TO: Mercedes-Benz and Freightliner Dealer Principals, General Managers, Sales Managers, Service Managers, Parts Managers	FROM: Thomas Brunner, Department Manager, Vehicle Compliance and Analysis Michael Scott, Vans Regulations & Certifications
RE: Recall Campaign 2017030018 MY 2015 Model 906 (Sprinter 2500,3500) Drive Shaft Catch Strap	DATE: May 26, 2017

Campaign No. :	<h2>Retrofit Drive Shaft Strap/Loop</h2>
2017030018	
<p>This is to notify you of the Recall Campaign Launch to retrofit an additional drive shaft catch strap on 2 MY15 Sprinter (906) vehicles. Please review the recall information below. The recall campaign will be visible on the www.safercar.gov website and may generate questions from customers. All affected VINs will be flagged as "OPEN" in VMI on May 26, 2017.</p>	
Background	
Issue	Daimler AG (DAG), the manufacturer of Mercedes-Benz Sprinter Vans, has determined that certain Sprinter 4x4 vehicles were not equipped with a drive shaft loss protection catch strap. As a result, in the event of a crash, the missing catch strap may lead to the drive shaft damaging the fuel tank, potentially increasing the risk of fuel loss and a fire. In addition, the vehicle does not

Figure 1 (1 Drive shaft, 2 Drive shaft strap/loop, 3 Bolts)

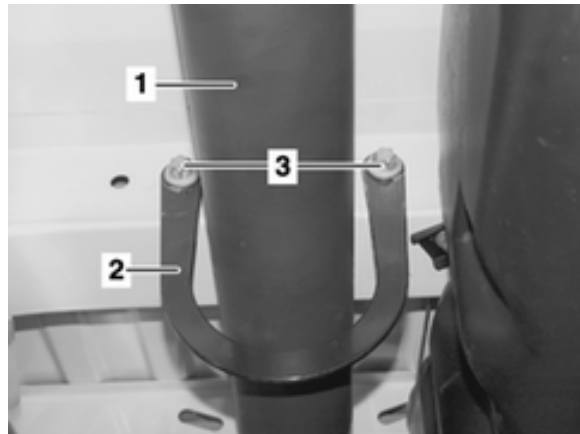
Daimler AG (DAG), the manufacturer of Mercedes-Benz Sprinter Vans, has determined that certain Sprinter 4x4 vehicles were not equipped with a drive shaft loss protection catch strap. As a result, in the event of a crash, the missing catch strap may lead to the drive shaft damaging the fuel tank, increasing the risk of fuel loss and a fire. In addition, the vehicle will not fulfill the requirements of Federal Motor Vehicle Safety Standard FMVSS 301 (Fuel System Integrity). An authorized Mercedes-Benz Sprinter dealer will retrofit the additional drive shaft catch strap to the affected vehicles.

1.  Retrofit drive shaft strap/loop (2, Figure 1) to cross member with mounting bolts (3).
 Torque mounting bolts (3) to: 70 Nm.
